Intersection ID: 51071	Main Street: KEMPSFORD_DR	Cross Street: GRICKLADE_DR	Location:	SW
ADA ID: 6E89AE688DB8	Ramp Type: PerpDiag	Initial Pass/Fail: Fail	Overall Compliance: No	Severity Score: 13.75

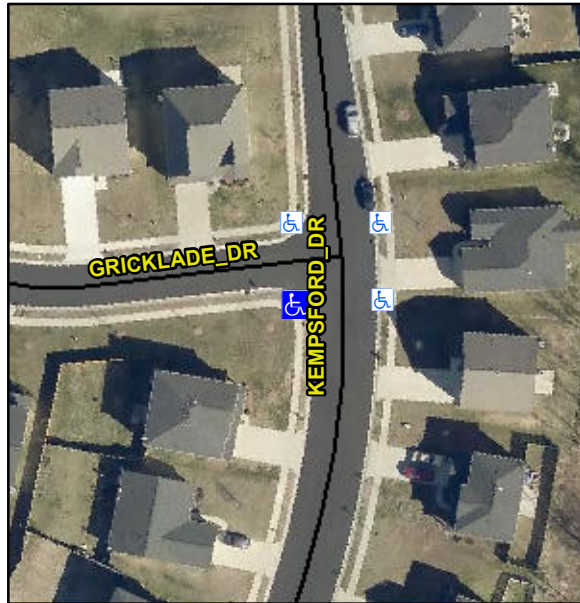
Not Found, R304.2.2, R304.5.3

Compliance	Description	Data	Compliance	Description	Data
N/A	Ramp Length (in)	48.0	No	Ramp Slope (%)	9.4
Yes	Ramp Width (in)	48.2	No	Ramp XSlope (%)	2.7
N/A	Flare Type LT	N/A	N/A	Flare Type RT	N/A
N/A	Flare Slope LT (%)	N/A	N/A	Flare Slope RT (%)	N/A
N/A	Flare Traversable LT?	N/A	N/A	Flare Traversable RT?	N/A
N/A	Landing Length (in)	N/A	N/A	DWS Provided?	N/A
N/A	Landing Width (in)	N/A	N/A	DWS Contrast?	N/A
N/A	Landing Slope (%)	N/A	N/A	DWS Length (in)	N/A
N/A	Landing X Slope (%)	N/A	N/A	DWS Full Width?	N/A
N/A	Landing Curb? (Y/N)	N/A	N/A	DWS Offset (in)	N/A
N/A	Shared Landing?	N/A			
N/A	Gutter Ponding?	N/A	N/A	Gutter Slope (%)	N/A
N/A	Gutter Lip Ht (in)	N/A	N/A	Gutter X Slope (%)	N/A
N/A	Painted X Walk1?	No	N/A	Painted X Walk2?	No
	X Walk 1 Direction	To E		X Walk 2 Direction	To N
N/A	X Walk 1 Width (in)	N/A	N/A	X Walk 2 Width (in)	N/A
	X Walk 1 Slope (%)	1.7		X Walk 2 Slope (%)	0.6
	X Walk 1 X Slope (%)	0.6		X Walk 2 X Slope (%)	1.4

Remove & Replace Curb Ramp With Two New Directional Ramps or Equivalent.
